Technical Service Bulletin: TSB180161	Released Date: 12-Nov-2018
Backside Idler Pulley and Bracket Removal for Peterbilt™ 520 Refuse Truck

Backside Idler Pulley and Bracket Removal for Peterbilt™ 520 Refuse Truck

Figure 1, Capscrew Locations with Idler Pulley Bracket Installed

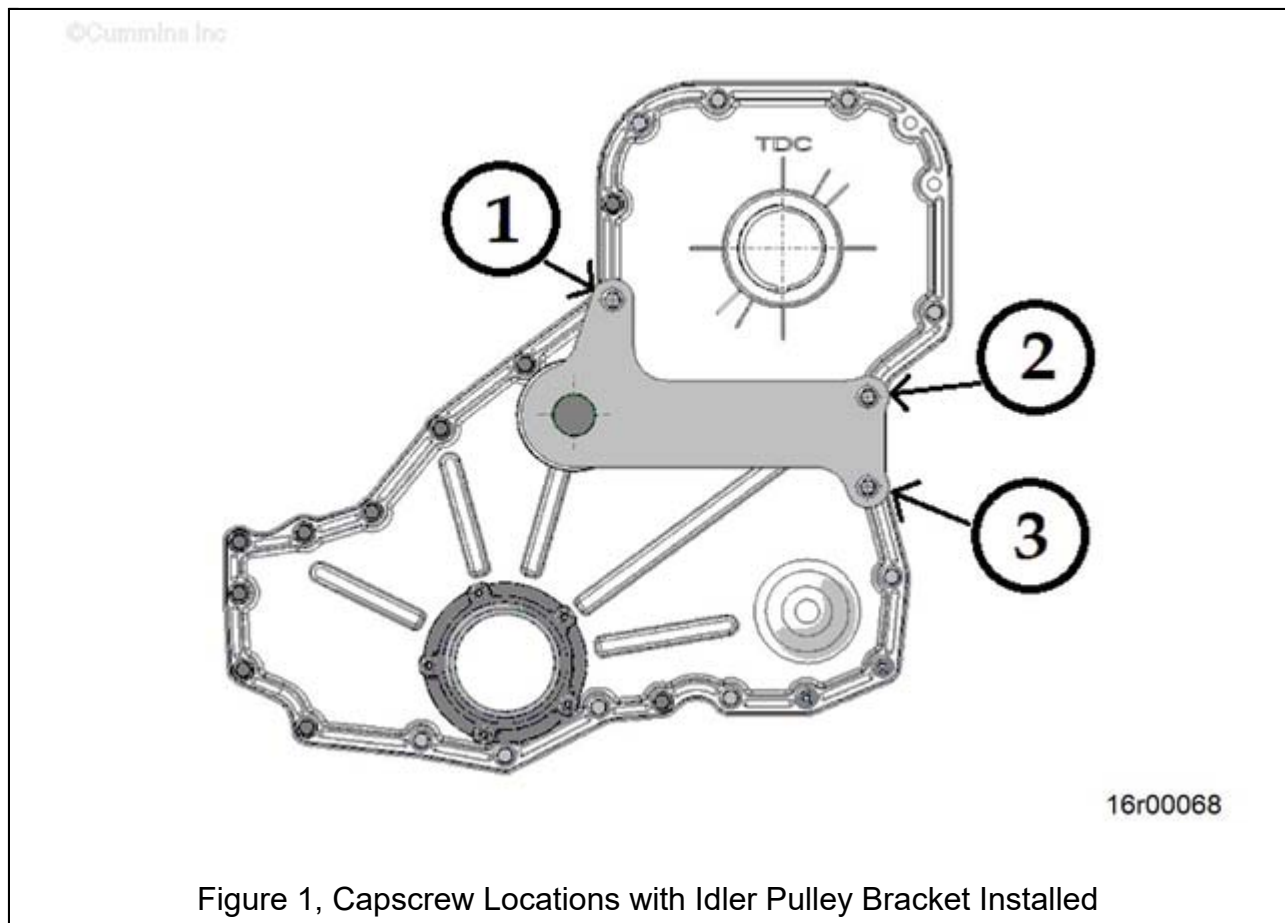
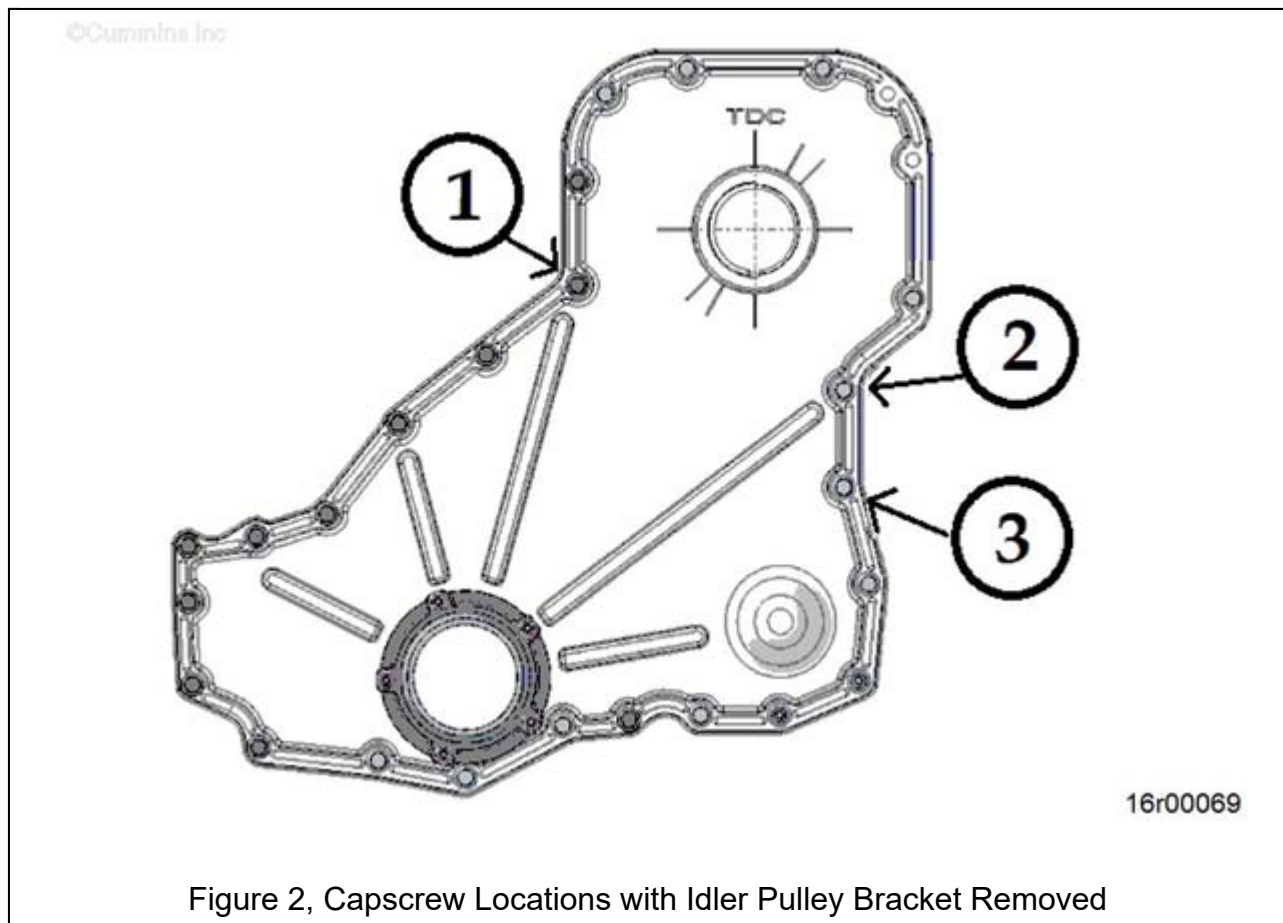
Backside idler pulley can experience malfunctions. This change reverts to a prior

arrangement that is more robust.

- Remove backside idler pulley and bracket and install new accesory drive belt. See Service Instructions section below.

1. Remove accessory drive belt.
 - See corresponding Service Manual. Reference Procedure 008-002.
2. Remove capscrews at locations 1, 2, and 3. See Figure 1 above.
3. Remove any broken capscrews, if necessary.
4. Discard accessory drive belt, cap screws, idler pulley, and bracket.

1. Install the long replacement capscrew, Part Number 3926863, at location 1. See Figure 2 above. Torque to 24N·m [212 in-lbs].
2. Install the two short replacement capscrews, Part Number 5261711 at locations 2 and 3. Torque to 24N·m [212 in-lbs].
3. Install new accessory drive belt, Part Number 3978284.
 - See corresponding Service Manual. Reference Procedure 008-002.
